Reference: BE/32/22/T

Location: The Old Cottage, 70 North Bersted Street, Bersted, PO22 9AE

Proposal: 1no. *Eucalyptus* tree (T1) - Fell to ground level. 1no. ash tree (T2) - Roadside limb to be reduced by 3-4m leaving a 6m branch, house side limb removed back to main trunk, and lift remaining crown to 6m above ground level

Figure 1. Ash tree (T2) proposed pruning work under consideration BE/32/22/T

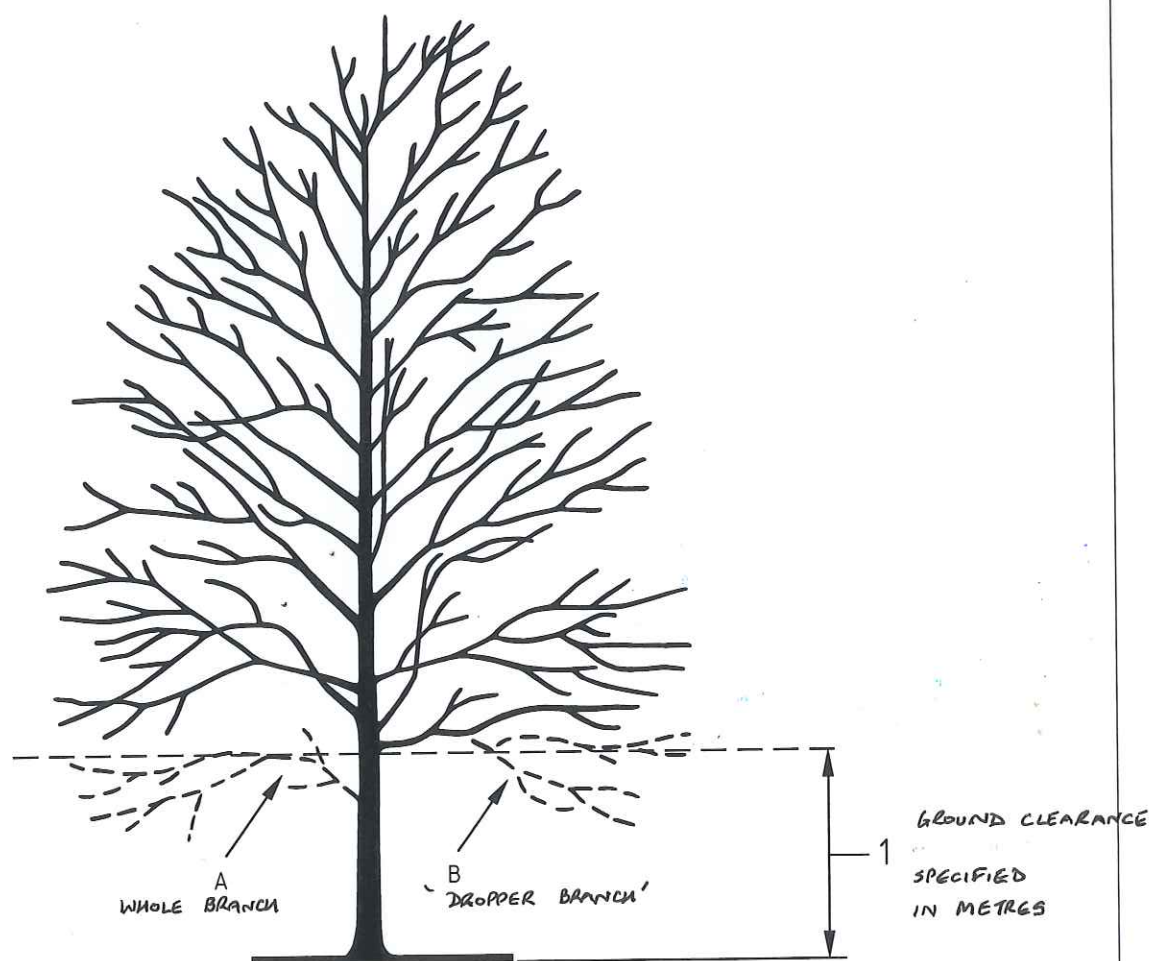
- T2 – Work specification is ambiguous hence I have clarified my interpretation of same by annotating the embedded photograph (figure 1). The application is determined on that basis.

-
- If the applicant agrees to the above proposal, then I would be able to recommend APPROVAL subject to the following condition:

Part a) Where whole branches are to be removed and final cuts made close to the trunk or branch union they are to be made as shown in Figure 2 of BS3998:2010

Part b) Where branches are to be shortened back the final cuts are to be made at the correct angle shown in BS3998:2010 and adjacent to a live bud or lateral.
